UNITED NUCLEAR
C O R P O R A T I O N

SUBJECT: Amendment to SNM-33: Increased Storage Capacity of
Building 235

501. BUILDING 235 (REFERENCE DRAWING 3712-204)

FIGURE 26

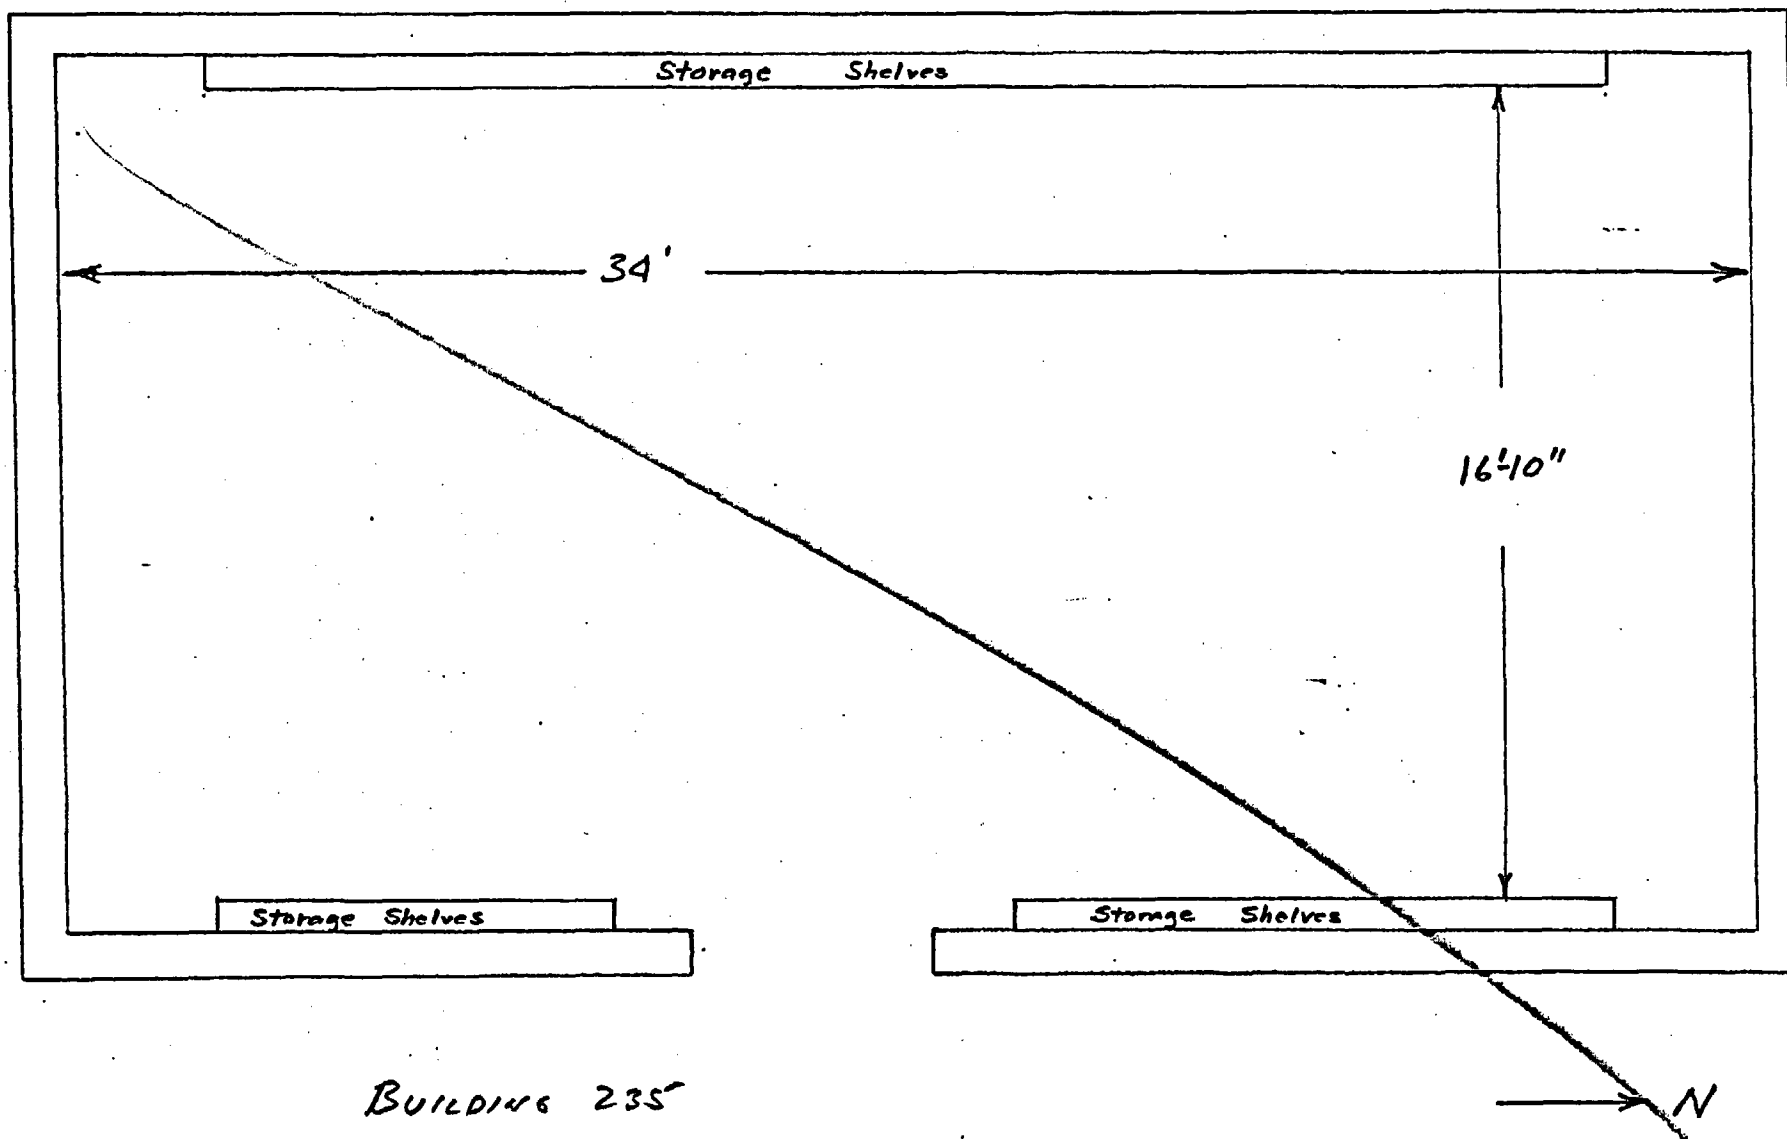
We have planned additional storage for Building 235 of our plant at Hematite, Missouri. This is to be accomplished by the addition of two concrete walls to the building. Details of this are described in Section 501, revised July 17, 1964 of "General Information Applicable to the Handling of Special Nuclear Material." A copy of this revised section is enclosed.

FIGURES 26 AND 27 SHOW A PLAN VIEW OF THIS BUILDING AND THE ARRANGEMENT OF STORAGE SHELVES. THE CONTAINER SIZES AND QUANTITIES STORED THEREIN ARE THE SAME AS LISTED IN PARAGRAPH 301.4.2. THE TOP TWO SHELVES WILL BE USED FOR THE STORAGE OF THE SHORTER CONTAINERS ONLY SUCH THAT THERE IS AT LEAST EIGHT INCHES SEPARATION TOP TO BOTTOM OF THE CONTAINERS.
